LOTS 13&14, BLK 6, EDWARD KROGH ADDN
PROPOSED LOTS 1 THRU 5.
GRADING AND DRAINAGE PLAN

TITLE: LOTS 13&14, BLK 6, EDWARD KROGH ADDN
PROPOSED LOTS 1 THRU 5.
STORM DRAIN AND GRADING DETAILS

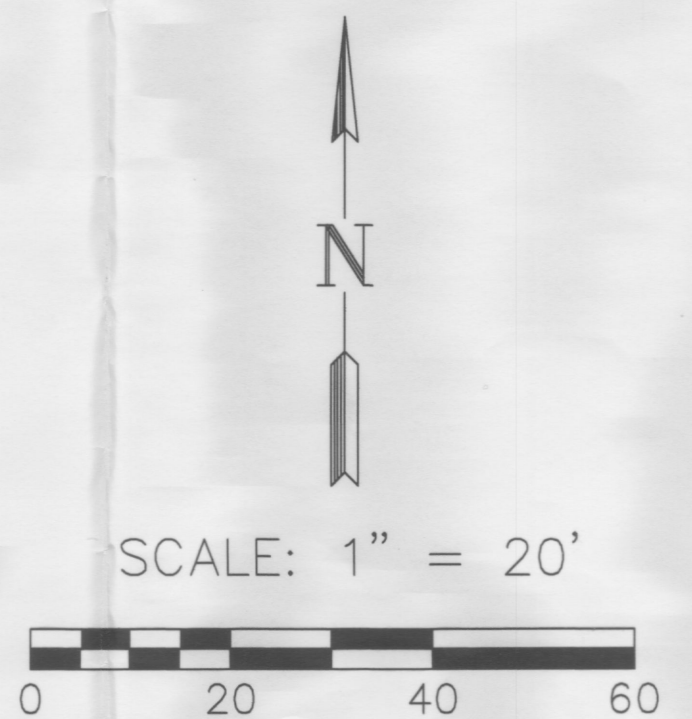
- O_2 99.4%
 48.8% B
 51.2% D
 $\rightarrow 3.48 \text{ cf/s}$
 $\rightarrow 5268 \text{ ft}^3$

TYPICAL PAVING SECTION
(VIEWED IN DIRECTION OF INCREASING STATIONS)

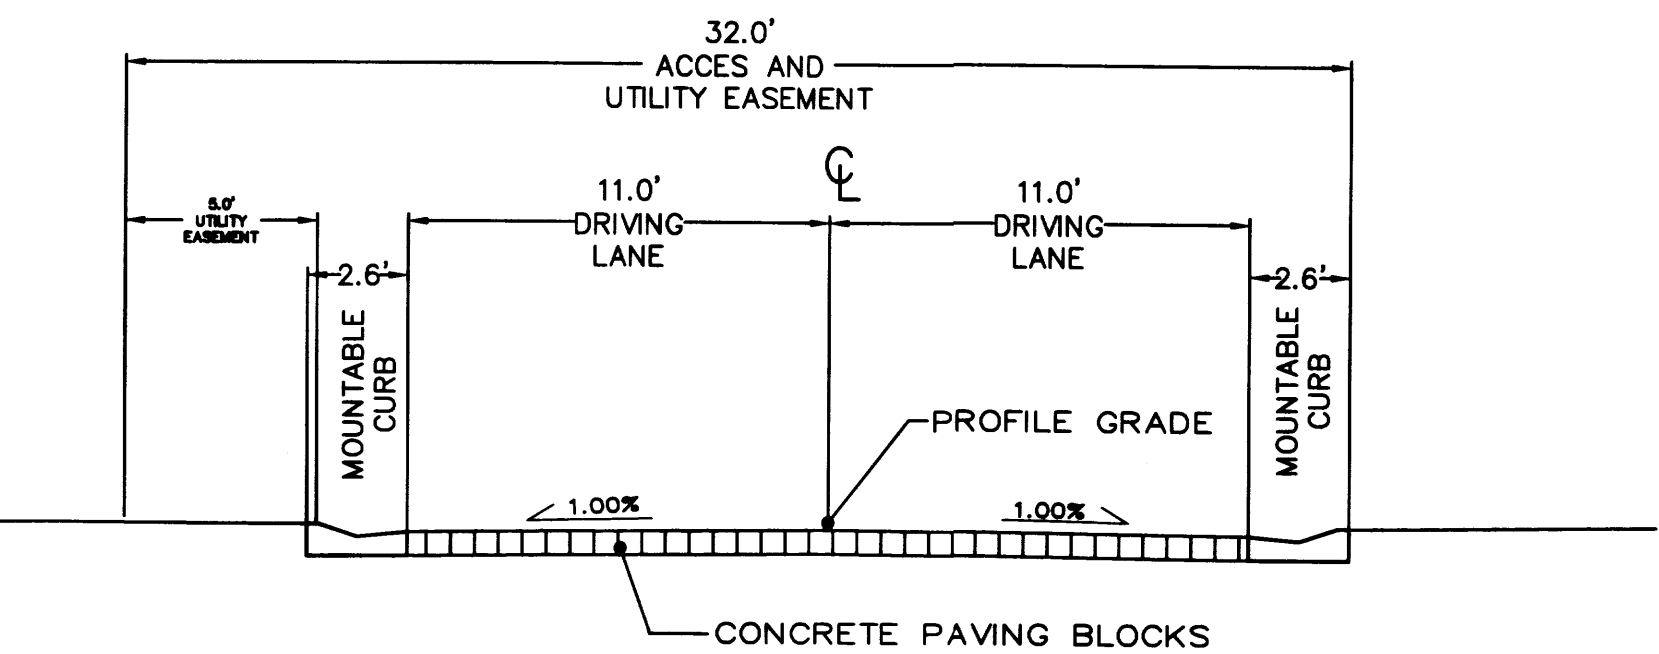
- (20) MOUNTABLE CURB PER COA STD DWG 2415A
- (21) LANDSCAPED YARD. GRADE TO DRAIN TO SIDEWALK CULVERT - SEE PLAN, SHEET 1
- (22) ~~RAISE EXISTING SAS M.H. COVER TO ELEV 4966.4~~
GRADE TO DRAIN AWAY FROM M.H. COVER
- (23) SEE PAVING SECTION THIS SHEET
- (24) MIN. 3' SEPARATION BETWEEN NEW SD AND EXISTING SAS AT CROSSOVER STA'S 10+29.0 AND 10+97.8
